ADDENDUM NO. 1
JUNE 14, 2013
LINCOLN AREA SEWER SEPARATION – CONTRACT #3C
PORTSMOUTH, NEW HAMPSHIRE

The following changes and information are hereby incorporated into the Contract Documents (Project Manual and Drawings).

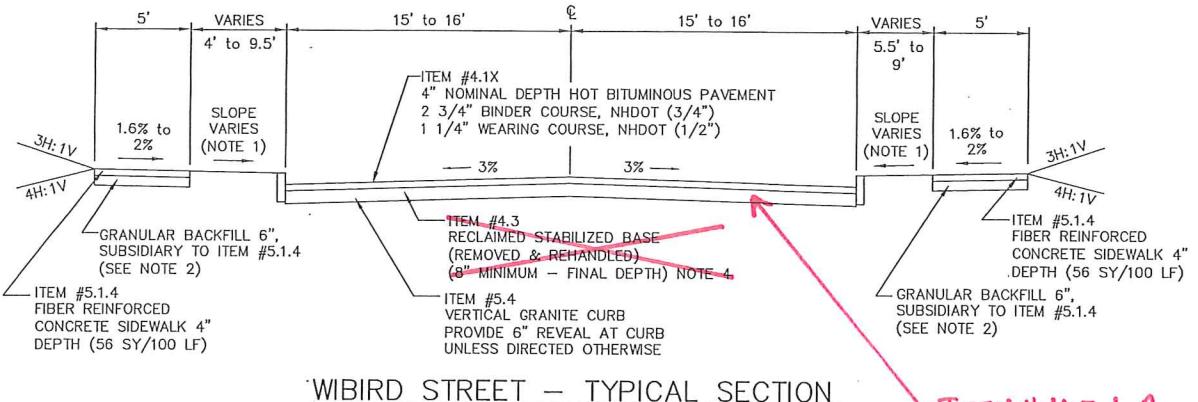
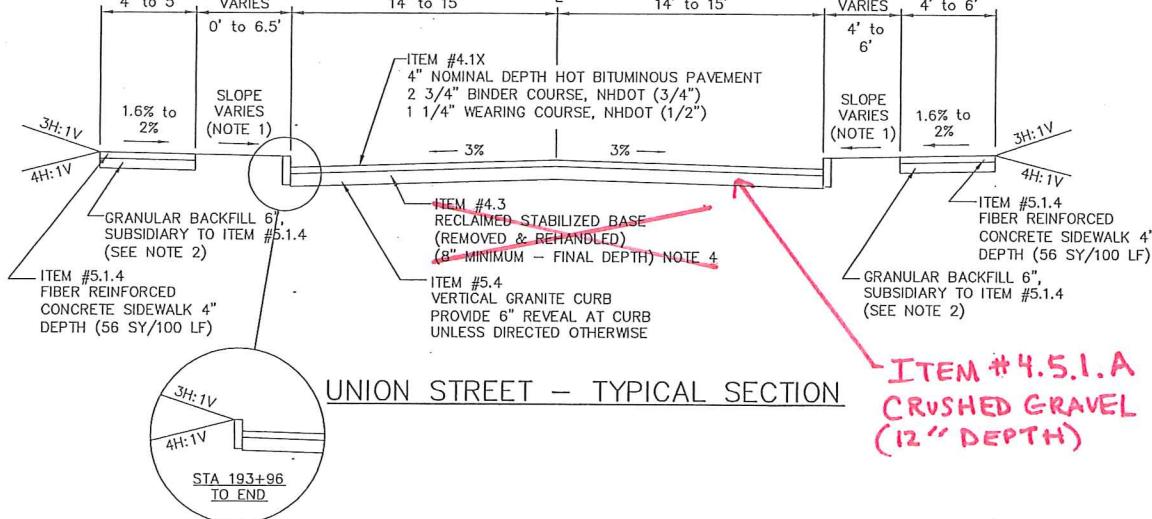
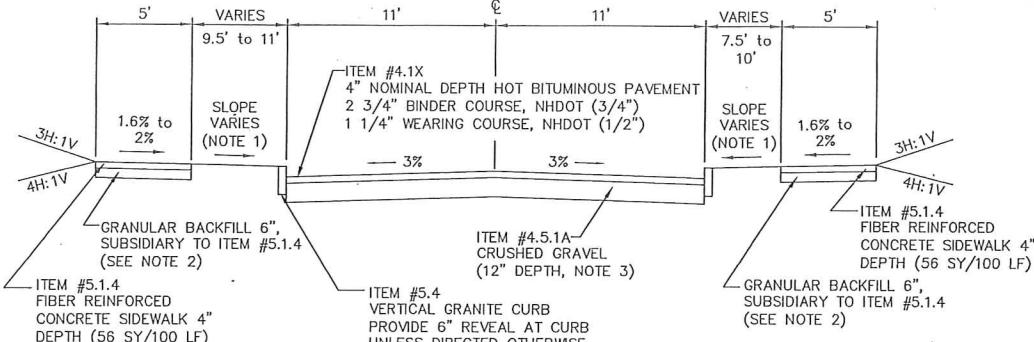
Delete DWG. NO G-7 entirely and Replace Roadway Quantity Schedules with Attachment D

ATTACHMENT E - ADDENDUM No.1

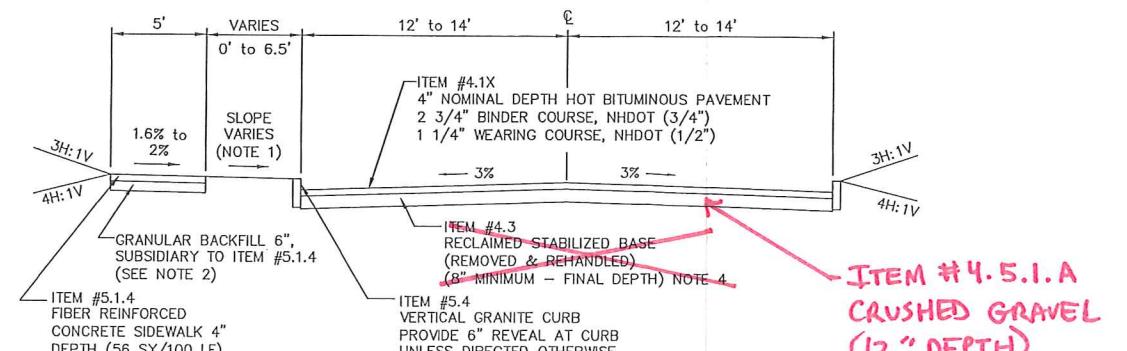
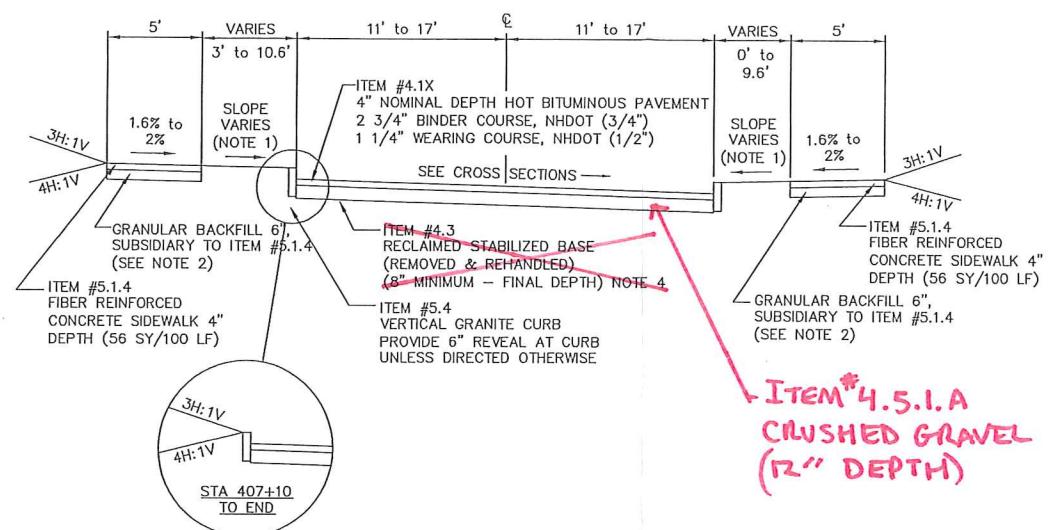
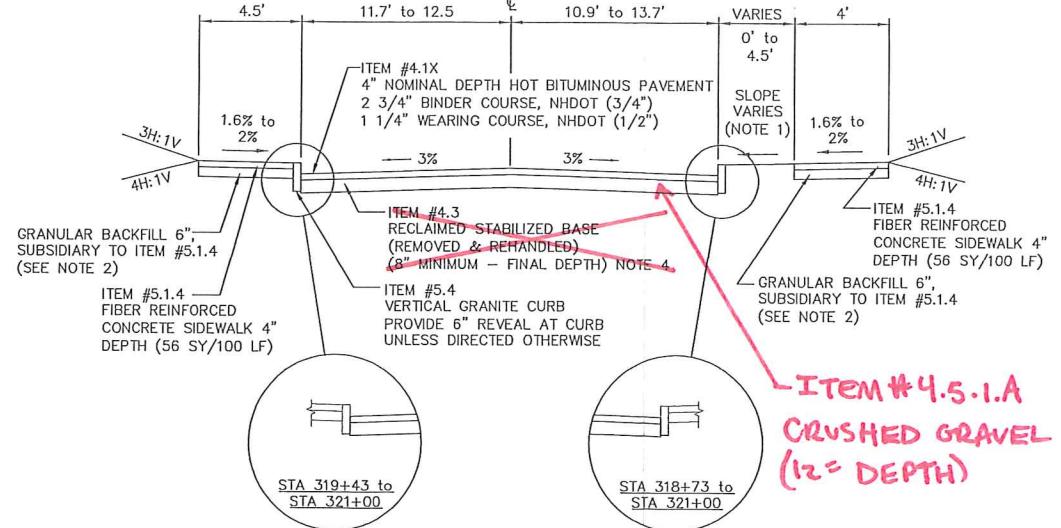
Delete DWG. NO X-1 entirely and Replace with Attachment E
